SERVICE INFORMATION BULLETIN

APPLICABILITY: 2017-20MY Impreza
 2018-20MY Crosstrek
 2019-20MY Forester

NUMBER: 12-296-20R

SUBJECT: Rear Frame and Stabilizer Bar Bracket
 Mounting Bolt- Design Changes

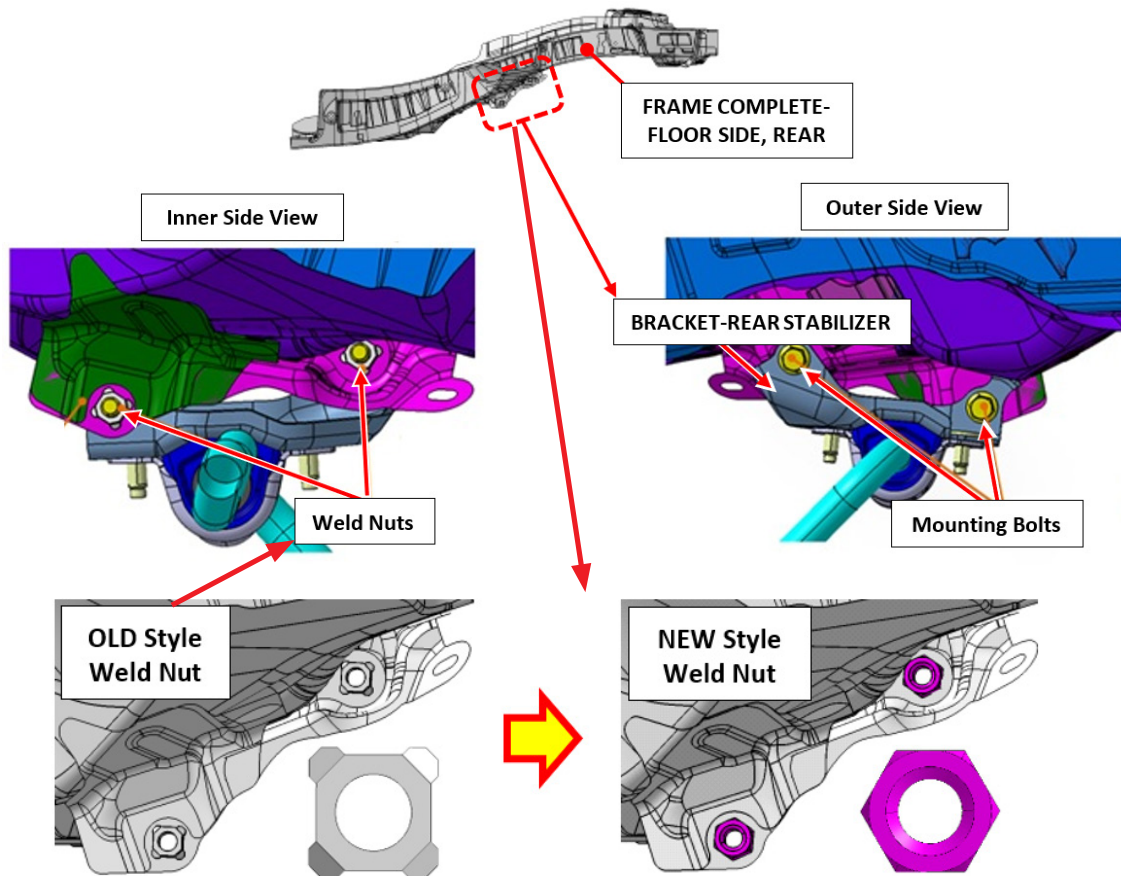
This Service Information Bulletin outlines design changes made to the rear frame section weld nuts and the mounting bolts used to secure the rear stabilizer bar brackets to them. The mounting bolts and the weld nuts incorporated into the rear frame sections used for securing the stabilizer bar brackets have both been revised to enhance torque retention. **In addition, a new torque sequence procedure has been developed and can be found on Page 3 of this bulletin.** Replacement of the bolts and/or brackets is not necessary as the original bolts are reusable. Always use the bolt(s) intended for use with the original factory installation as they are not interchangeable.

New Flange Bolt Identification Information:

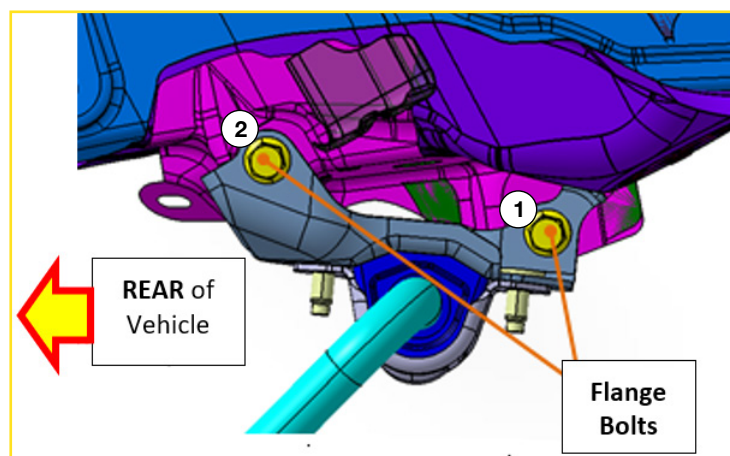
- The new Flange Bolts **listed in the table on pg. 1** are NOT compatible with weld nuts used in the original frames. Using the new-style Flange Bolts on the original frames will damage the weld nuts.
- The original Flange Bolts (p.n. 010108200) are reusable and readily available if needed.
- The new Flange Bolts (**p.n. 20058FL010**) have a special lubricant applied to their threads and are now One-Time use items.
- There have been no changes to the part numbers of the stabilizer bar brackets.

New P.N. 20058FL010	Old P.N. 010108200

<p>DETAILS:</p> <ul style="list-style-type: none"> • Size: M8 • Under-head length: 25 mm • Flange diameter: 19mm • Color: With lubricant (green) • One-Time Use Part 	<p>DETAILS:</p> <ul style="list-style-type: none"> • Size: M8 • Under-head length: 20 mm • Flange diameter: 17mm • Color: Without lubricant (plated) • Bolt Is Reusable
